Jeff Heyn Multi-Tenant JSP13-62

Consideration of the request of GRB Novi LLC for Preliminary Site Plan and Stormwater Management Plan approval. The subject property is located in Section 16, at 46035 Grand River Avenue, east of Beck Road in the I-1, Light Industrial District. The subject property is 7.7 acres and the applicant is proposing to demolish a portion of the existing building, update the building façade, install additional parking and provide area for landbanked parking.

**JSP13-62 Jeff Heyn Multi-Tenant
Revised Preliminary Site Plan Review
Plan Date: 10-16-13**

**SUBJECT: Jeff Heyn Multi-Tenant Building, JSP13-0062,
Traffic Review of Revised Preliminary Site Plan, PSP13-0171**

Photo 1. Looking south at woodland line/greenbelt (right side of photo).
(ECT, September 25, 2013).

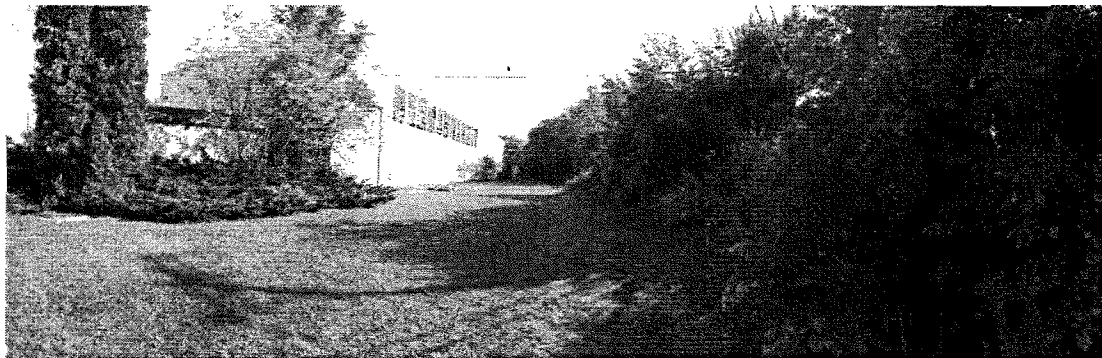
The Plan indicates a *Future Drive and Parking Area* in the northwest portion of the site. This area backs up to a woodland line/greenbelt that is regulated by the City of Novi.

Although the current Plan includes a 10' future greenbelt along the west property boundary in this area, the Plan does not include any existing tree survey information. It is currently unclear if the Applicant proposes the removal of regulated trees along the western property boundary in this location.

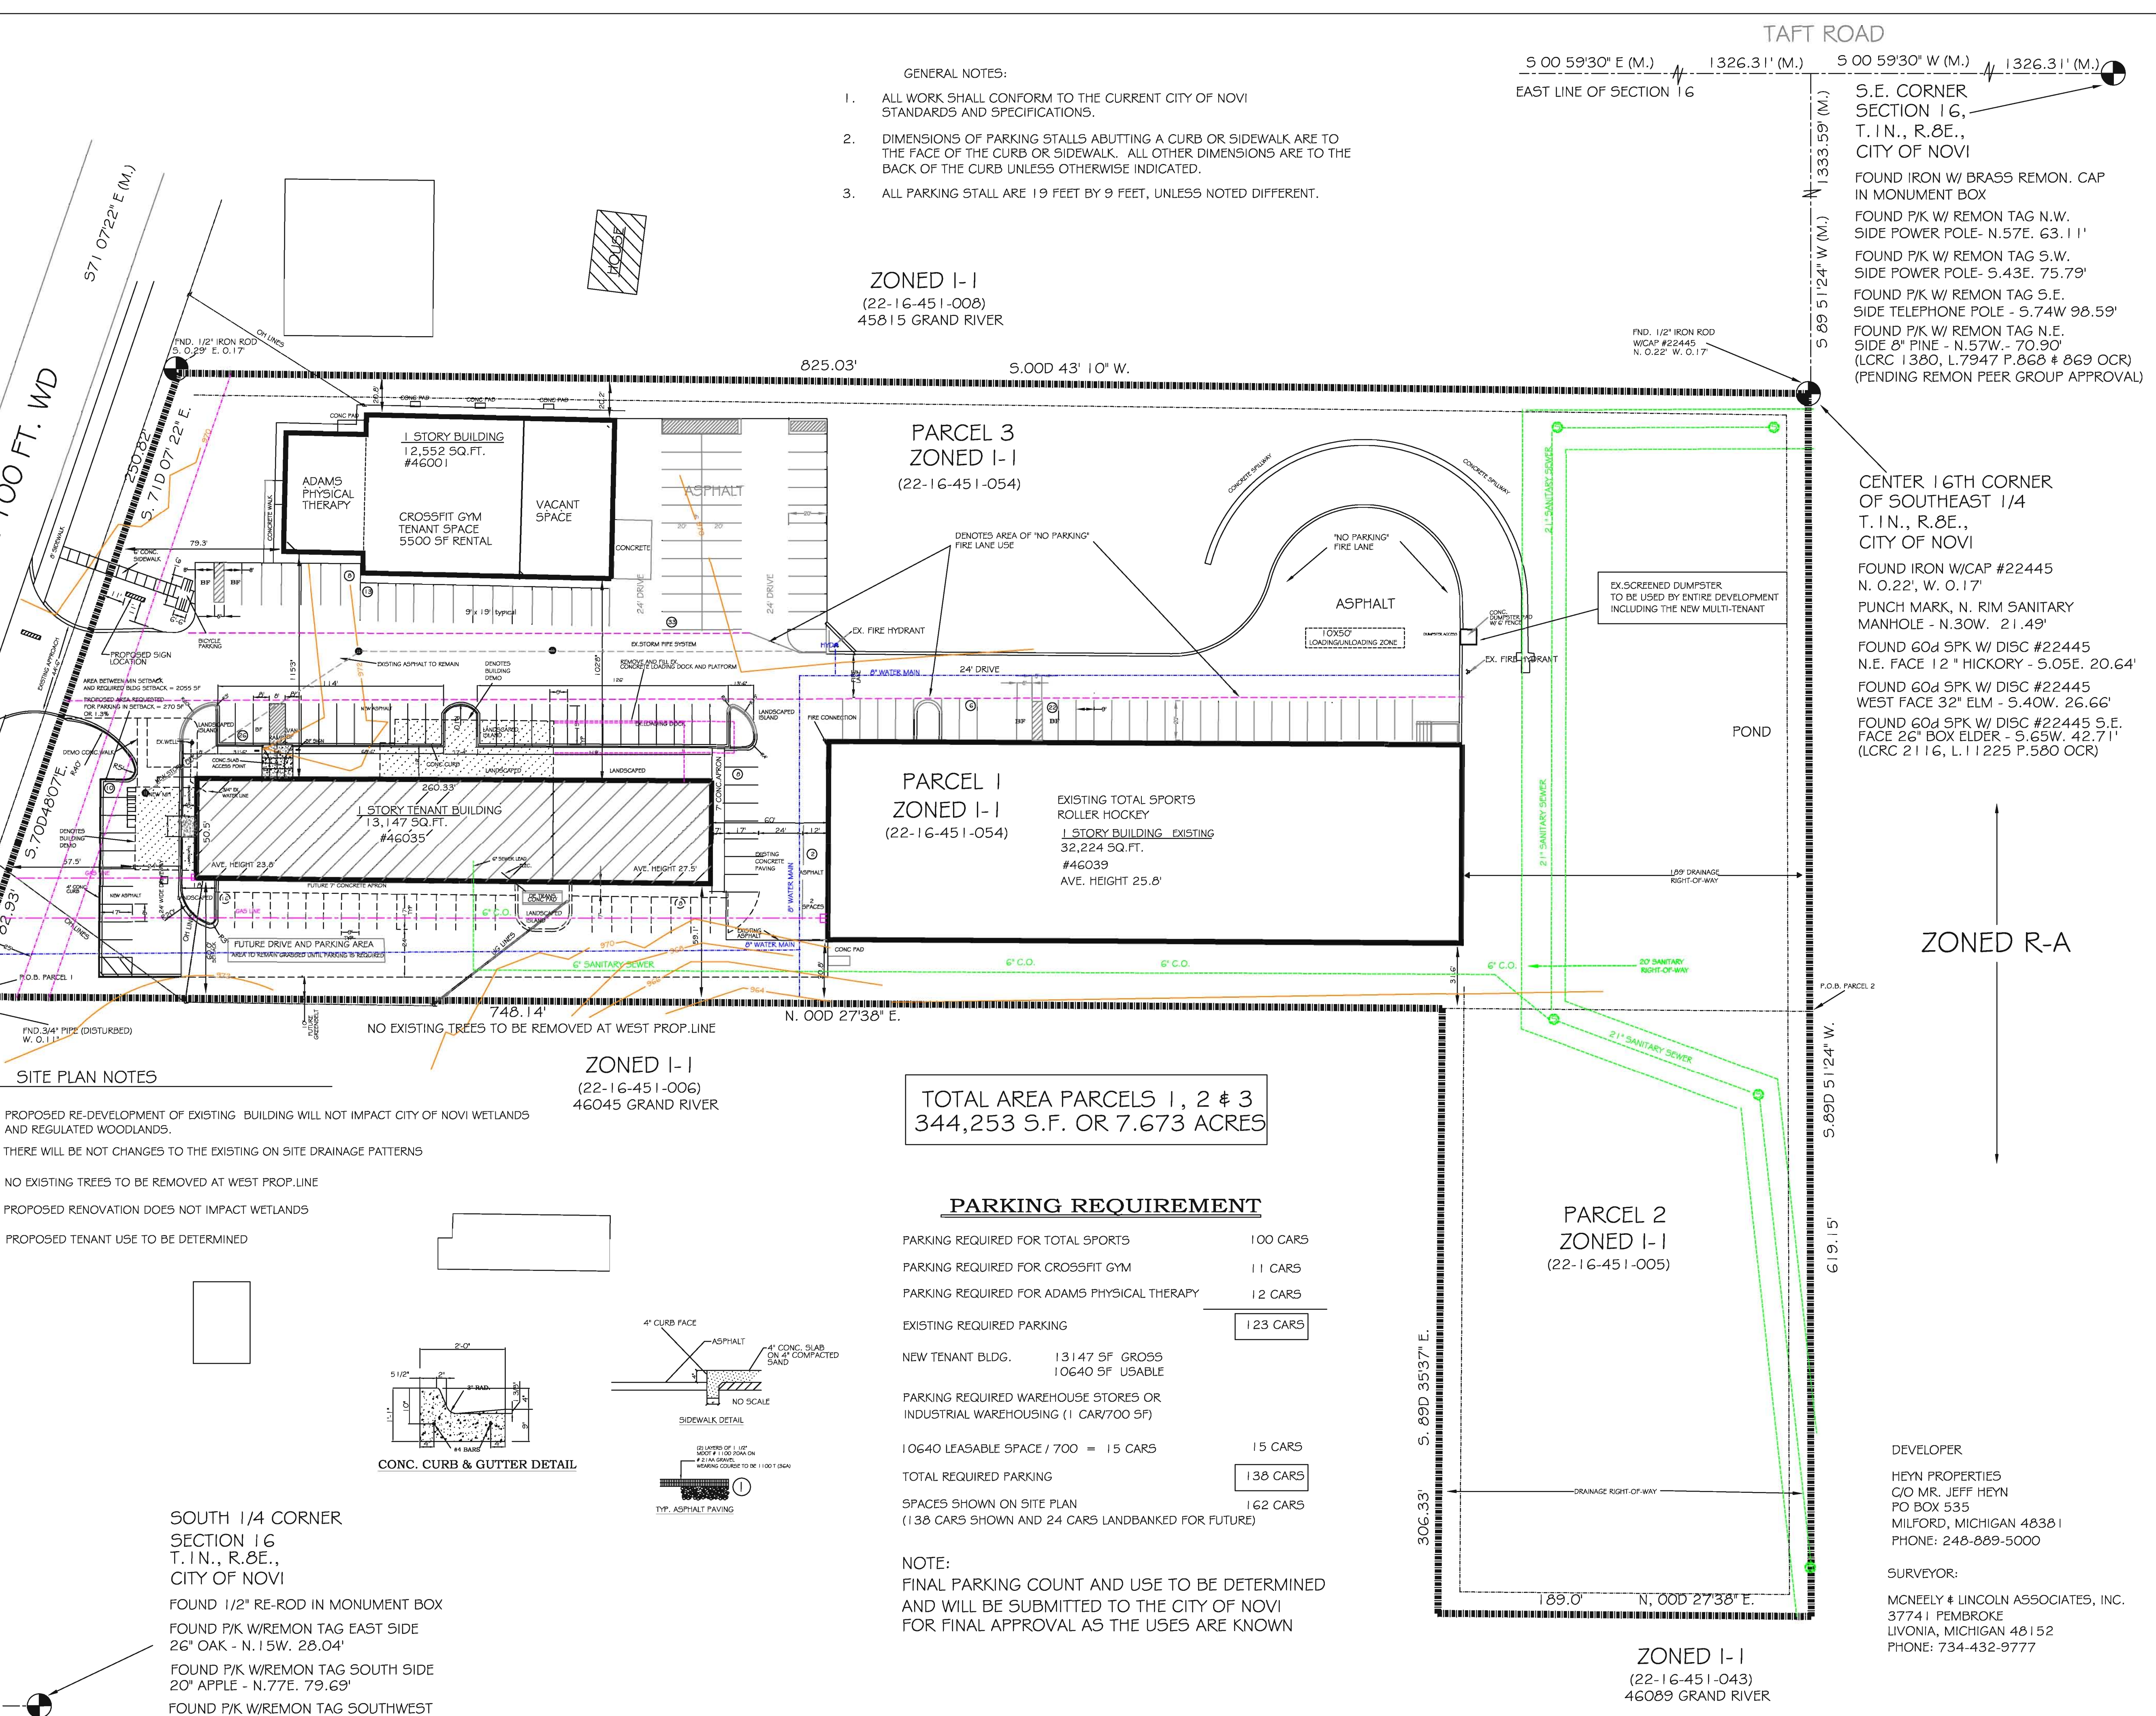
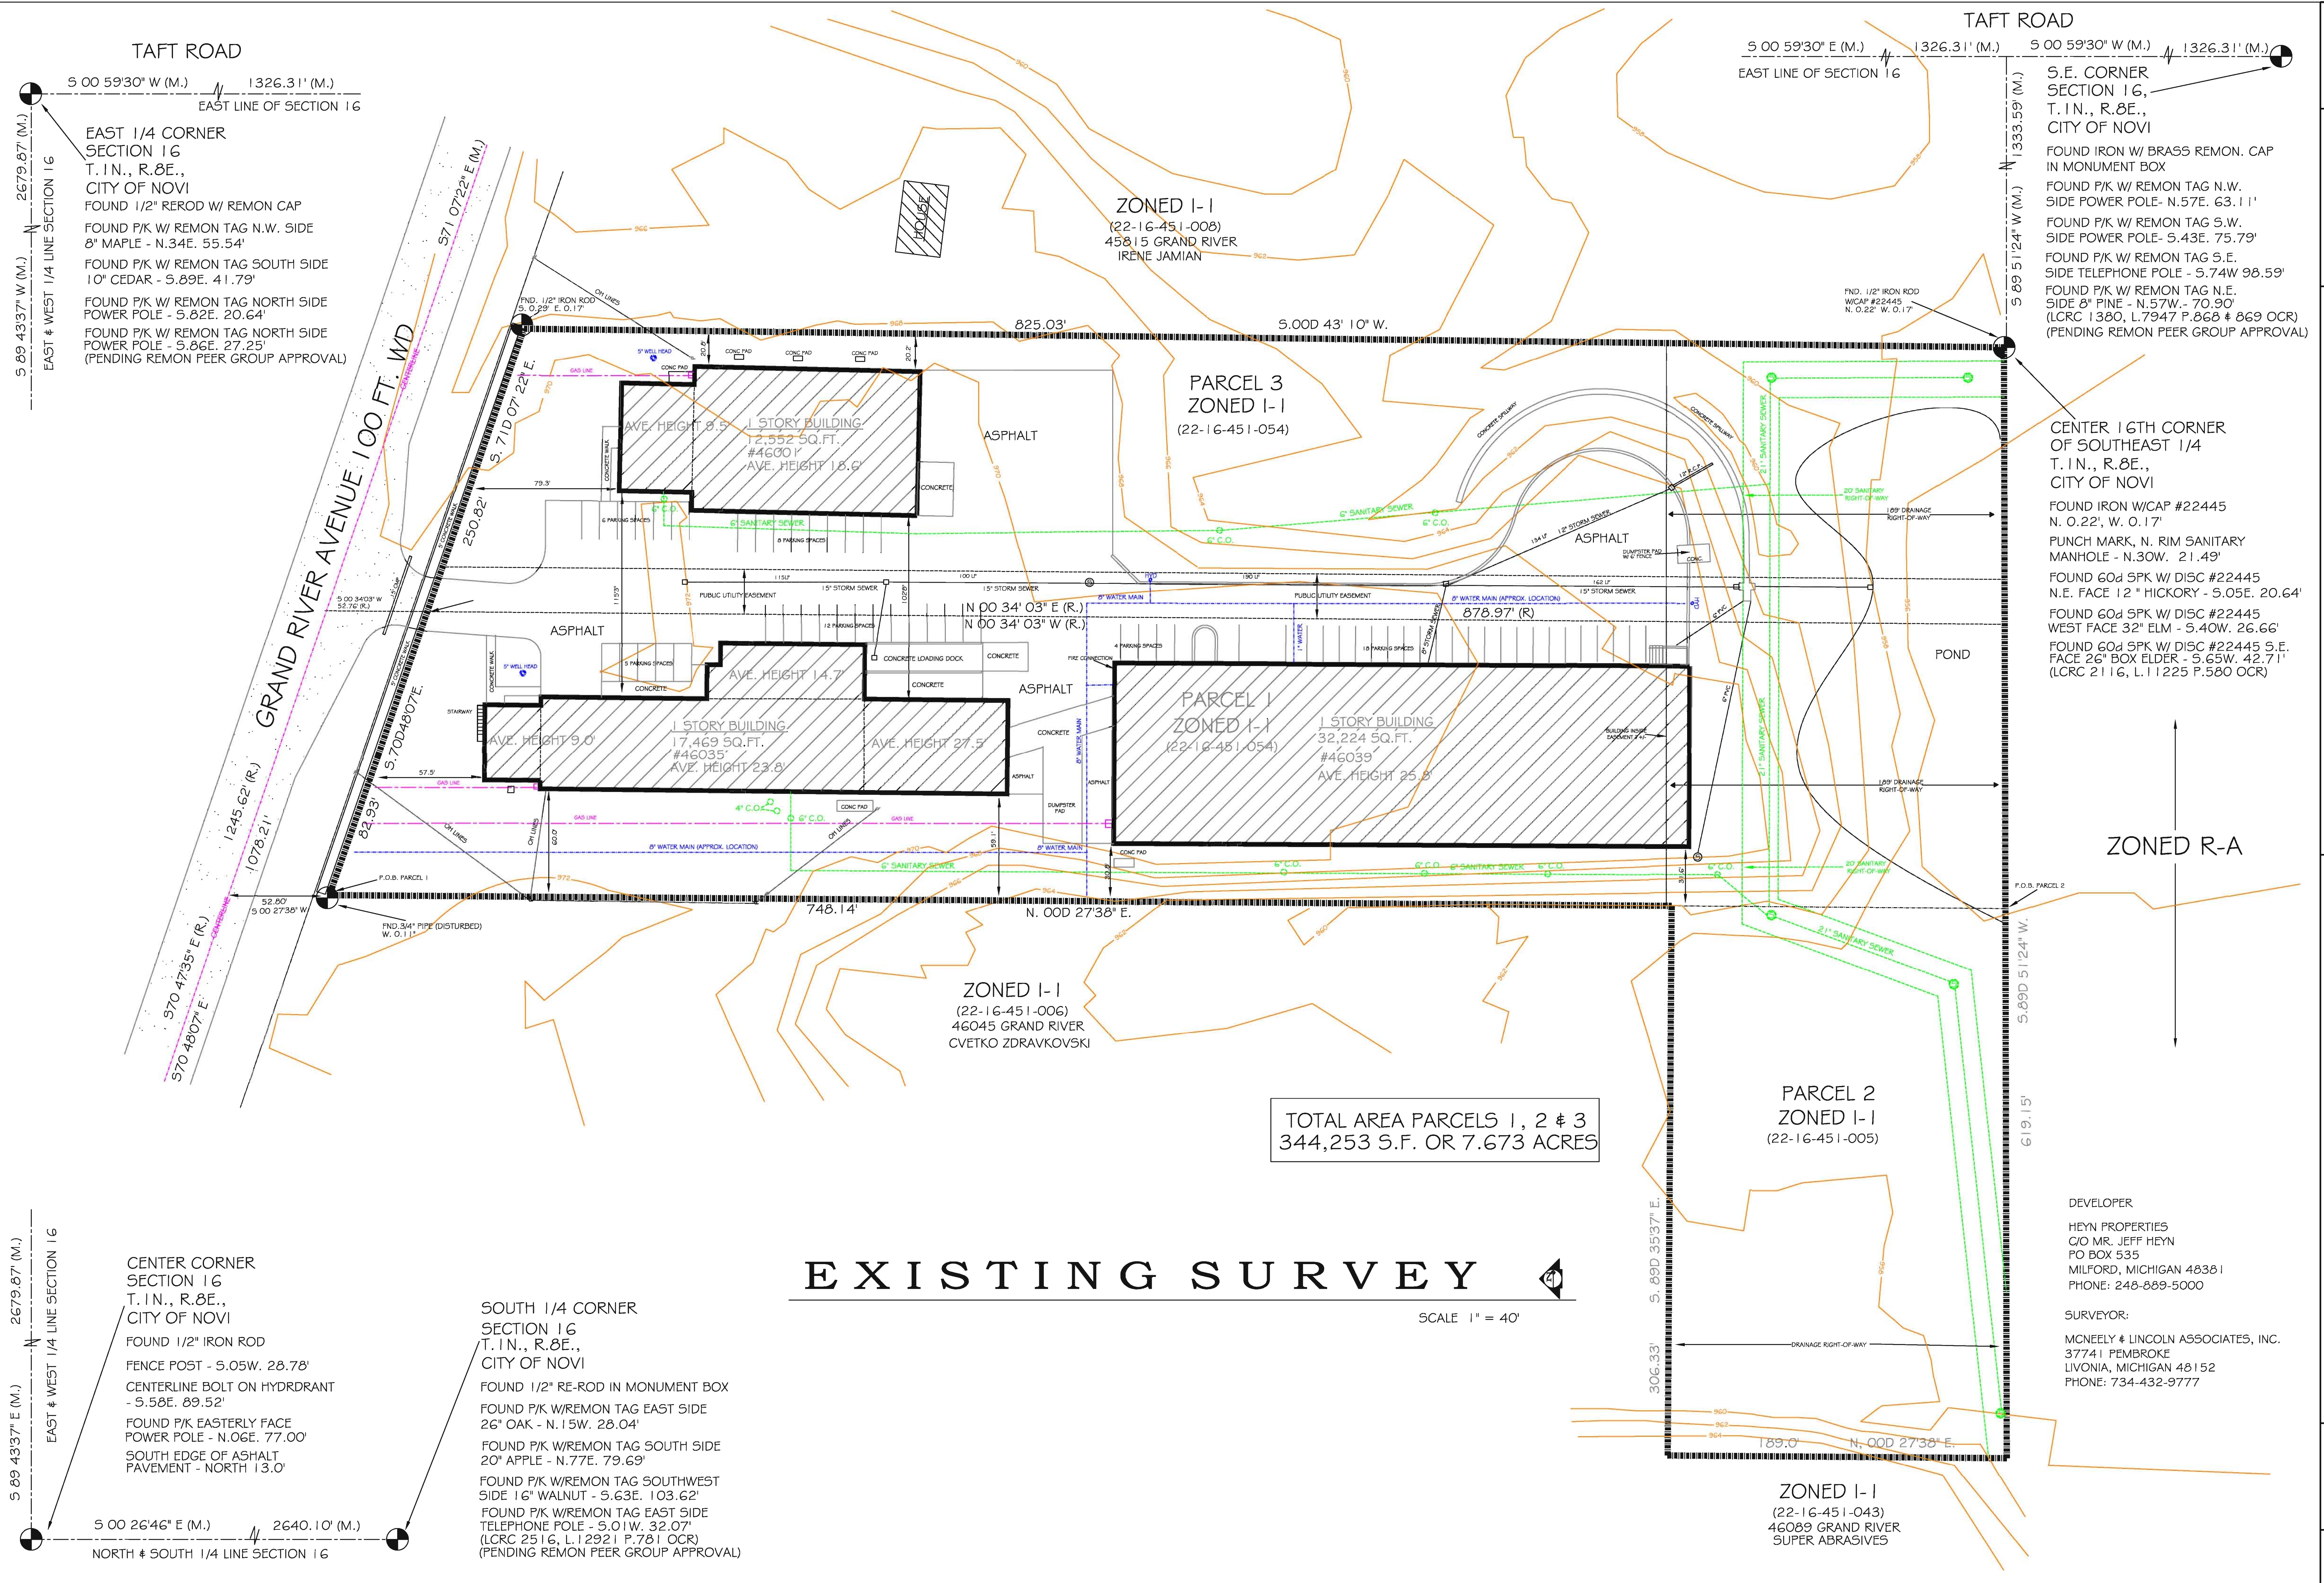
9. As pointed out in our previous review, **“Both barrier-free parking spaces adjacent to the 8-ft-wide access aisle qualify as van-accessible – even if only one is required – and should be properly designated as such.” Also, the two barrier-free spaces scale 9 ft wide on sheet C-1 but are dimensioned 8 ft wide on sheet A-2; this discrepancy should be corrected.**

10. As also pointed out in our previous review, **the detail for barrier-free signing on sheet A-2 “does not utilize the indicated MMUTCD-standard signs and is therefore unacceptable.” Specifically, since the MMUTCD does not offer a combined sign for van-accessible spaces, it is Novi-standard practice to use two signs for such spaces: a R7-8 – which has the word “ONLY” below the wheelchair symbol – supplemented by a R7-8P sign – reading “VAN ACCESSIBLE.”**

13. **The future concrete apron along the west side of the building has been widened to 7 ft as requested, but it is incorrectly dimensioned as 5 ft wide on sheet A-2.**

9. As pointed out in our previous review, **“Both barrier-free parking spaces adjacent to the 8-ft-wide access aisle qualify as van-accessible – even if only one is required – and should be properly designated as such.” Also, the two barrier-free spaces scale 9 ft wide on sheet C-1 but are dimensioned 8 ft wide on sheet A-2; this discrepancy should be corrected. REVISED**

10. As also pointed out in our previous review, **the detail for barrier-free signing on sheet A-2 “does not utilize the indicated MMUTCD-standard signs and is therefore unacceptable.” Specifically, since the MMUTCD does not offer a combined sign for van-accessible spaces, it is Novis-standard practice to use two signs for such spaces: a R7-8 – which has the word “ONLY” below the wheelchair symbol – supplemented by a R7-8P sign – reading “VAN ACCESSIBLE.” REVISED**

13. **The future concrete apron along the west side of the building has been widened to 7 ft as requested, but it is incorrectly dimensioned as 5 ft wide on sheet A-2. NOTE CORRECTED**

EAST ELEVATION

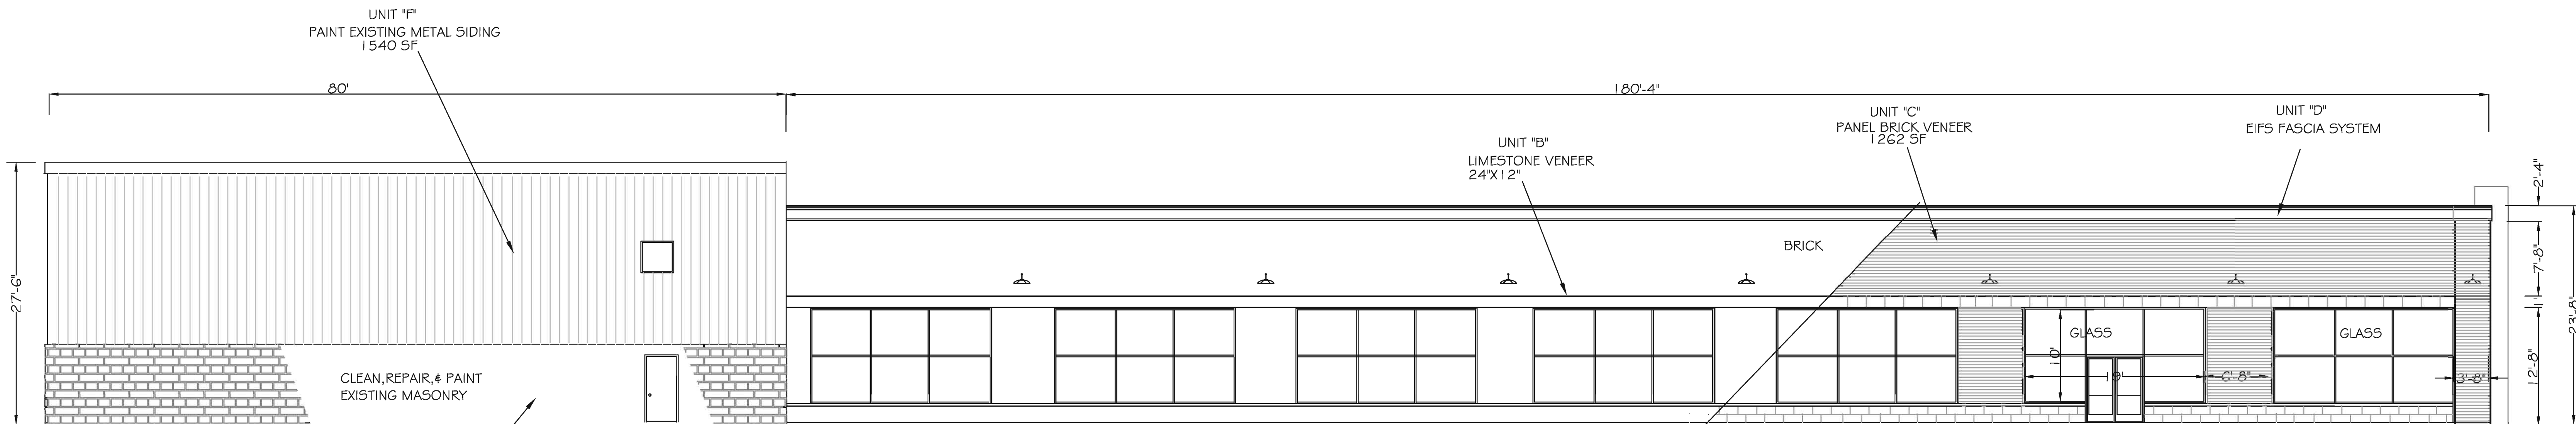
12. A ramped sidewalk is proposed between the barrier-free access aisle and the building, at a location some 43 ft south of the building’s north end. However, the building’s east elevation (on sheet A-4) shows the only doors some 10½ ft south of the building’s north end. **The doors should be shifted south, and potentially the sidewalk shifted north as well, so that these two key design elements align with each other.**

12. A ramped sidewalk is proposed between the barrier-free access aisle and the building, at a location some 43 ft south of the building’s north end. However, the building’s east elevation (on sheet A-4) shows the only doors some 10 1/2 ft south of the building’s north end. **The doors should be shifted south, and potentially the sidewalk shifted north as well, so that these two key design elements align with each other. REVISED**

STORM WATER PROFILE

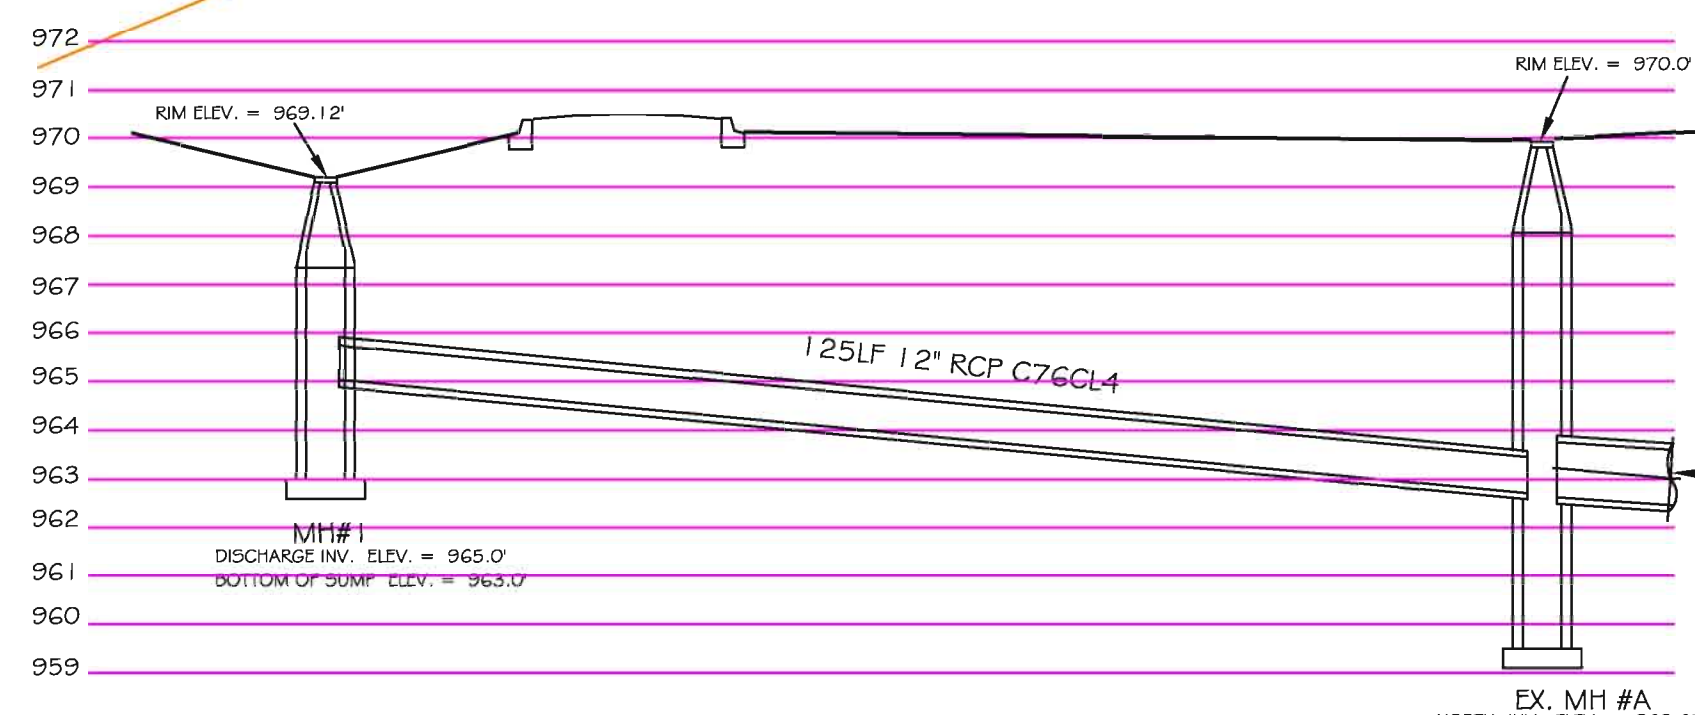
6. Revise the storm sewer profile at Ex. Manhole "A" to match the 0.8 diameter depth for the pipe size increase from 12 inches to the existing 15-inch storm sewer.
7. Verify that the existing storm sewer is functioning as originally designed (free of blockages, obstructions, etc.) and is capable of accepting additional flow from the proposed catch basin.
